Dipsea Ranch: Tree Removal Analysis Deficient in MND

Dipsea Ranch - MND is deficient in Analysis of Wetland Impacts

Dipsea Ranch - MND is deficient in Analysis of Unstable Road Use

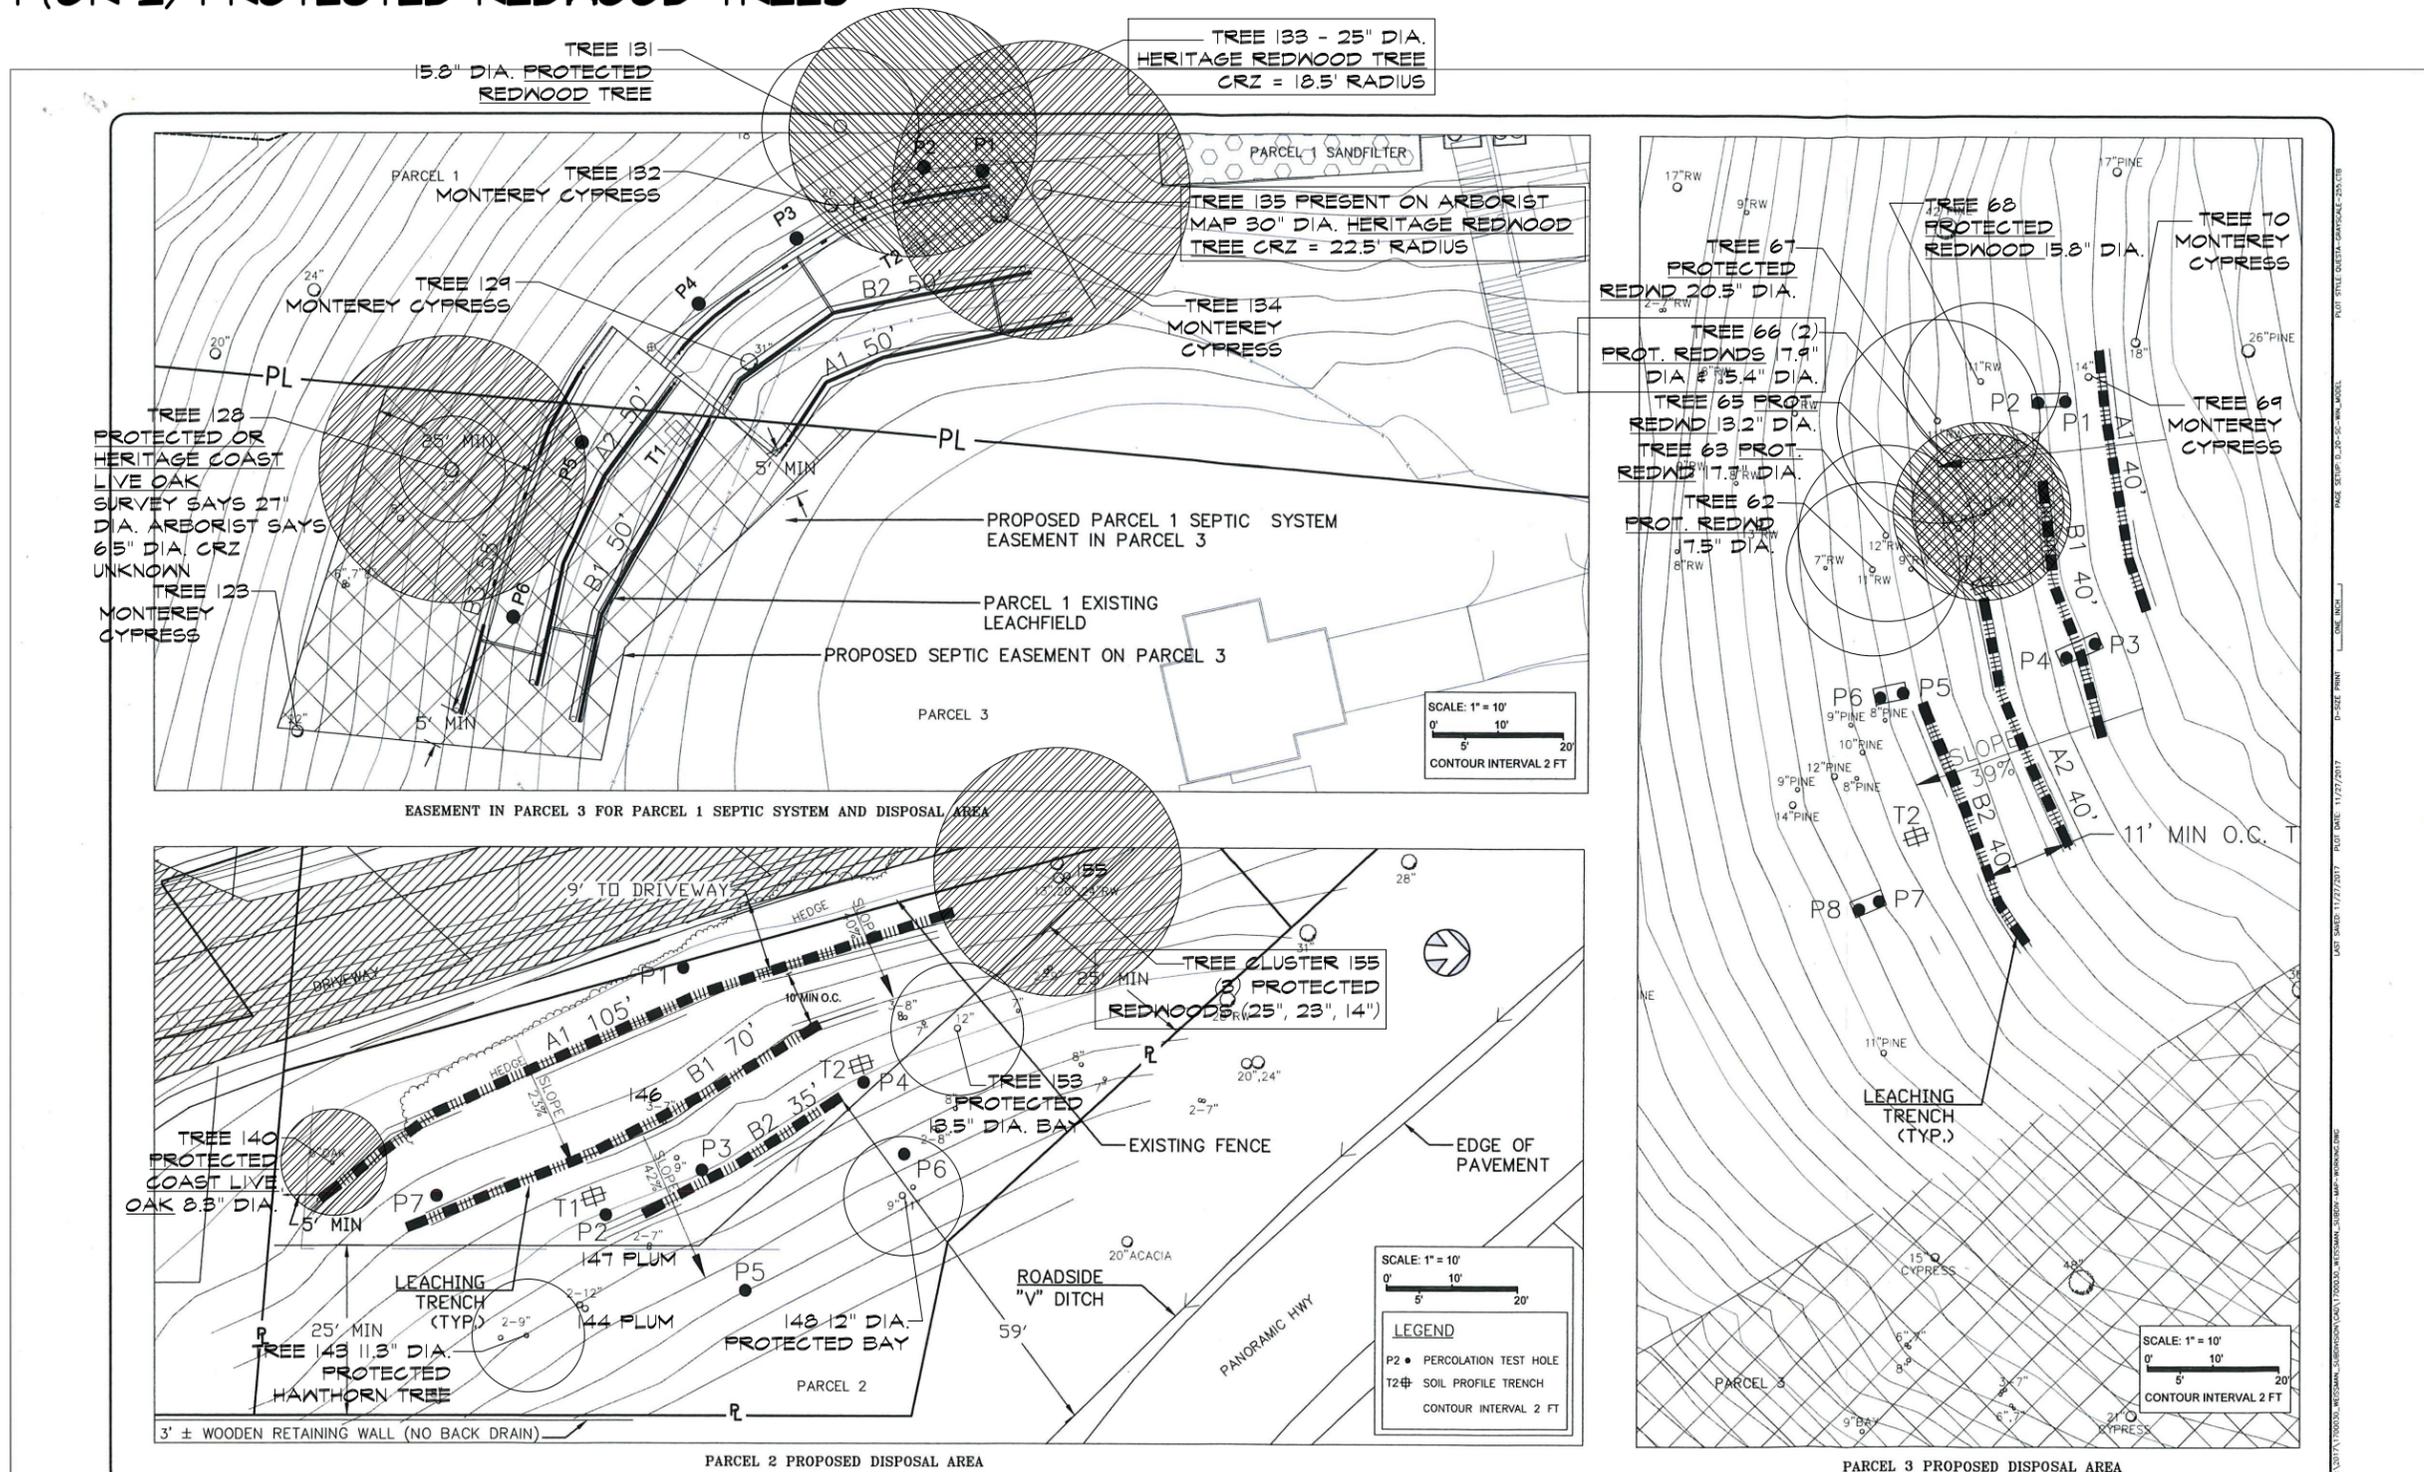
The removal of protected or heritage trees is not acknowledged, and the MND states their removal would be significant.

WASTEWATER DISPOSAL AREAS
PARCELS 1, 2 & 3
MARIN CO A.P. 046-161-11

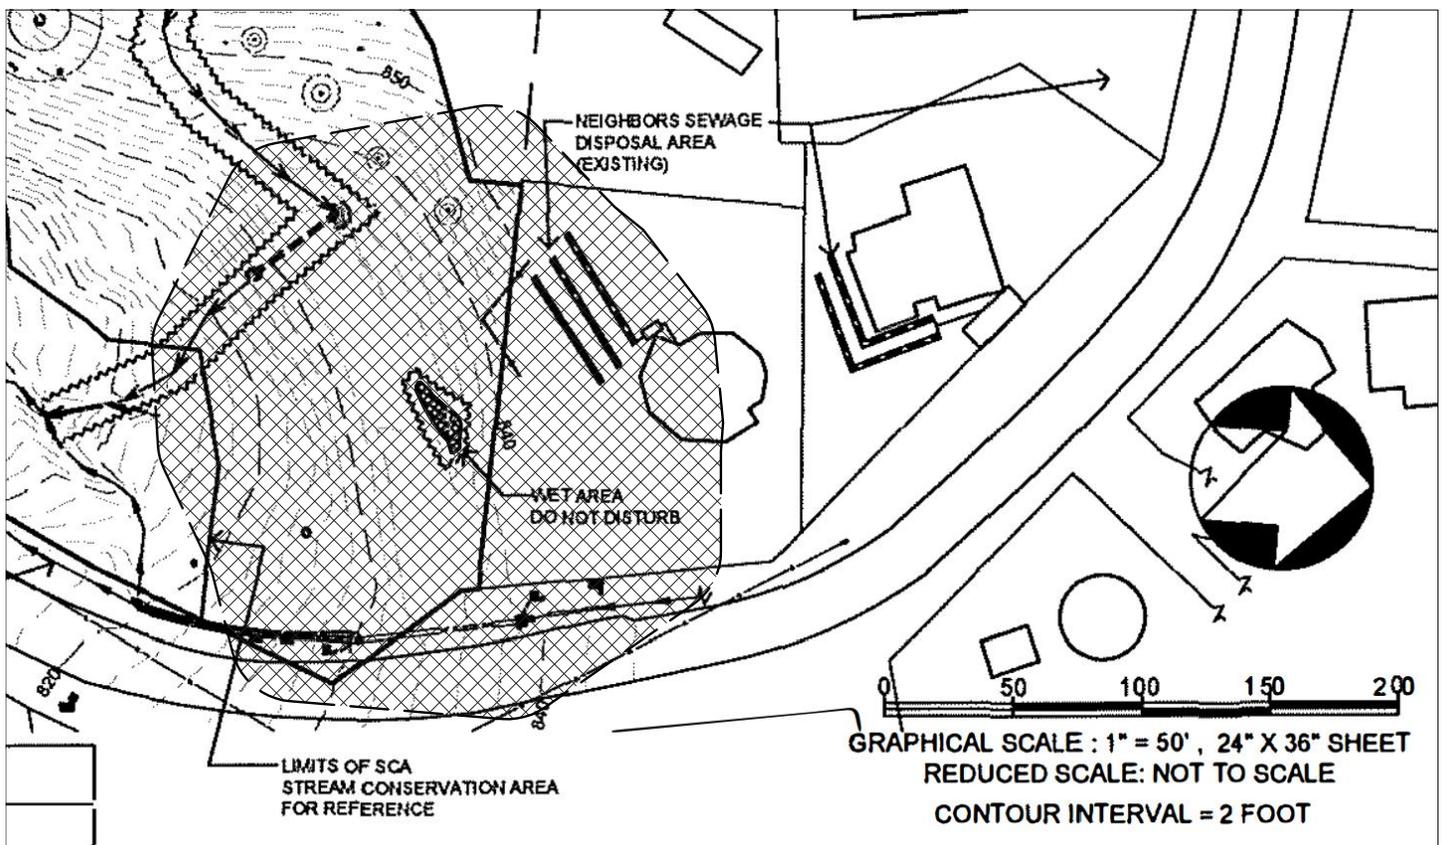
The following page illustrates the planned septic systems with the critical root zone of protected and heritage trees (CRZ based on tree radius x 1.5, per MND) overlaid, showing damage to 8 protected and 2 (or 3) heritage trees, more than described in both reports.

PARCEL ONE SEPTIC SYSTEMS LOCATED WITHIN CRITICAL ROOT ZONE OF:

**2 (OR 3) HERITAGE REDWOOD TREES,
1 (OR 2) PROTECTED REDWOOD TREES**

**PARCEL THREE SEPTIC SYSTEMS LOCATED WITHIN CRITICAL ROOT ZONE OF:
2 PROTECTED REDWOOD TREES**

PARCEL TWO SEPTIC SYSTEMS LOCATED WITHIN CRITICAL ROOT ZONE: 3 PROTECTED REDWOOD TREES, 1 PROTECTED LIVE OAK TREE

**EXPLORATION PLAN/
 GEOLOGIC MAP**
 455 Panoramic Highway
 Mill Valley, California

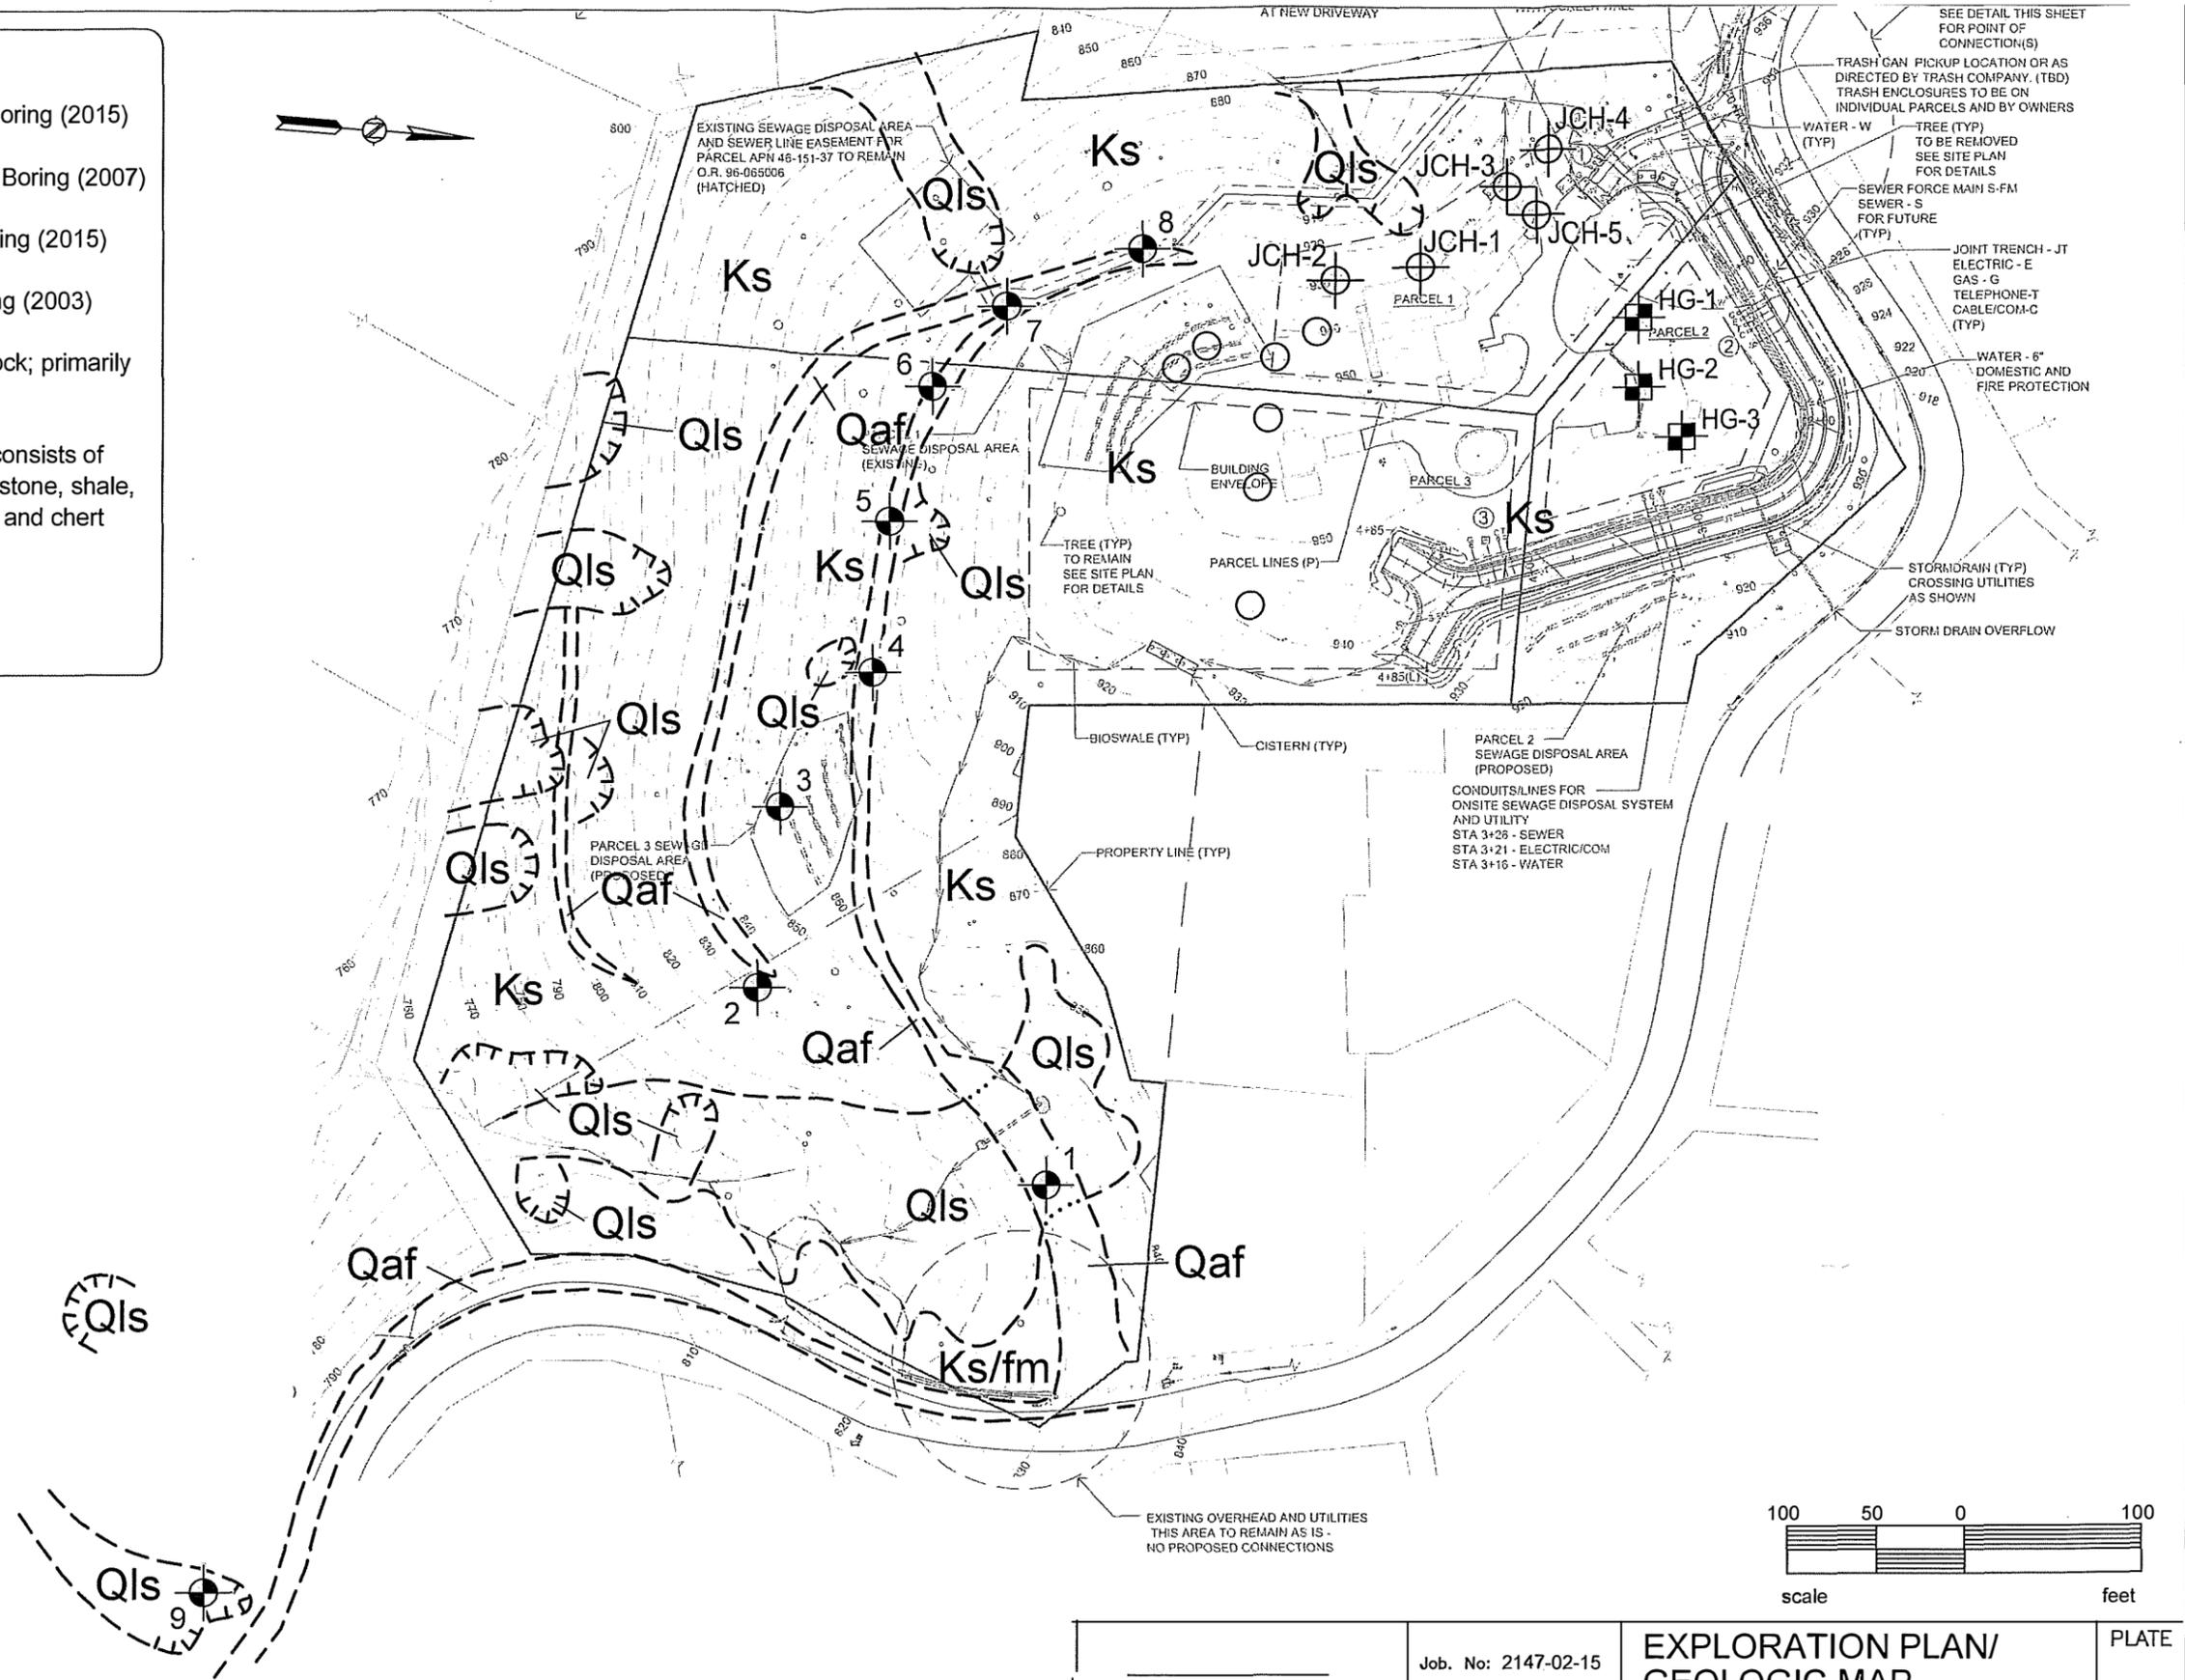
The updated geotech report re-affirms that the road is unstable, and then describes massive amounts of construction that would be required to stabilize the road. See attached.

The Initial Study and MND completely fail to address the use of this road by the applicant. It is very possible that use of this road by any automobile could cause sever environmental damage to both the adjacent wetland and the streams below it by causing more landslides.
